# Building Permit Application

Permit No.: B17002830

Amendment, Permit # B17002830

I am requesting to amend Permit # B17002830 at  
5021 Lindera Court Ellicott City md 21042 to  
add media room to finished basement

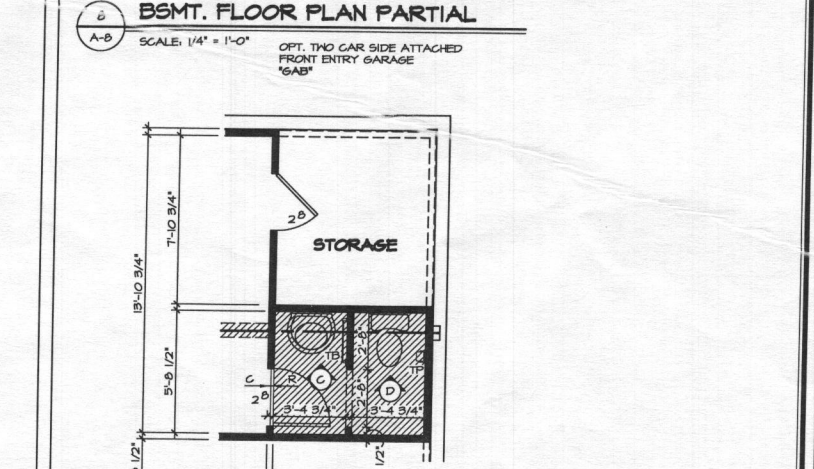
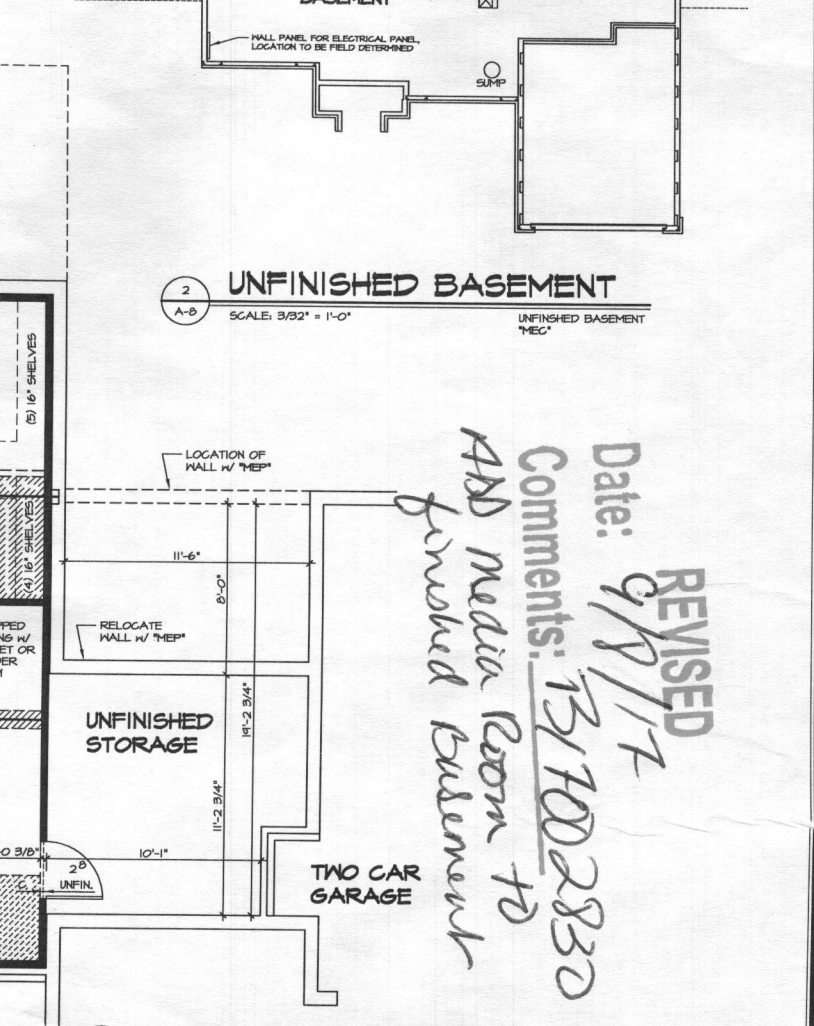
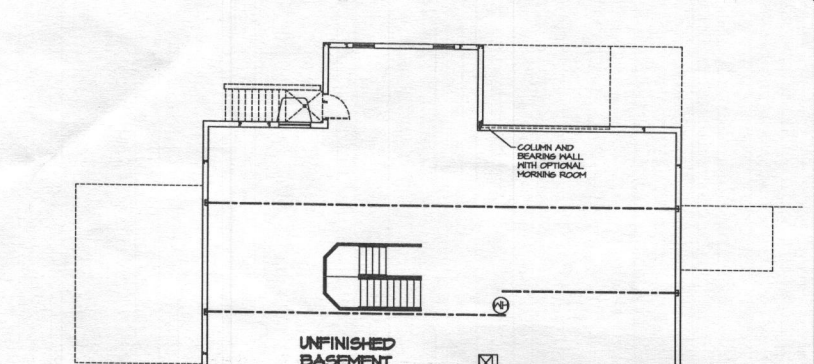
**REVISED**  
Date: 9/8/17  
Comments: 13/1002830  
ADD Media Room to finished Basement
